Docket Number:	12-AFC-02
Project Title:	Huntington Beach Energy Project
TN #:	201046
Document Title:	City of Huntington Beach, AES-SACQMD Update for City Council Study Session 10-21-2013
Description:	N/A
Filer:	Tiffani Winter
Organization:	City of Huntington Beach Planning and Building Department
Submitter Role:	Public Agency
Submission Date:	10/24/2013 3:12:13 PM
Docketed Date:	10/24/2013

AES – AQMD Update

City Council Study Session

Landscape & Surf City USA Option with Wire Mesh Screen

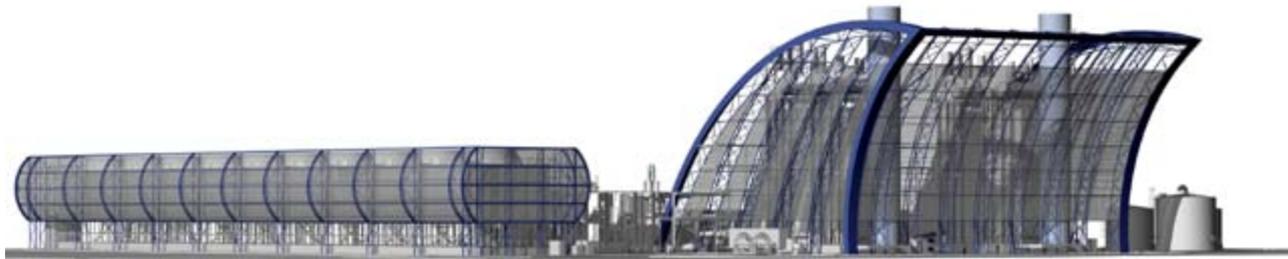
- Reduction in mass and scale from the current structures is positive
- Preferred design is a combination of architectural mesh with the classic surfboards
- Improve the architectural mesh design with curve or wave shape
- Incorporate artistic flair into the architectural mesh design
- Increase the playfulness of the design while striving to reduce the bulk
- Include nighttime lighting on the surfboards
- Delete the surfboard from the Magnolia Street side and provide improved architectural mesh only on the power blocks
- Paint treatment only on the air cooled condensers is acceptable
- Consider the maintenance and efficiency needs when redesigning the architectural mesh
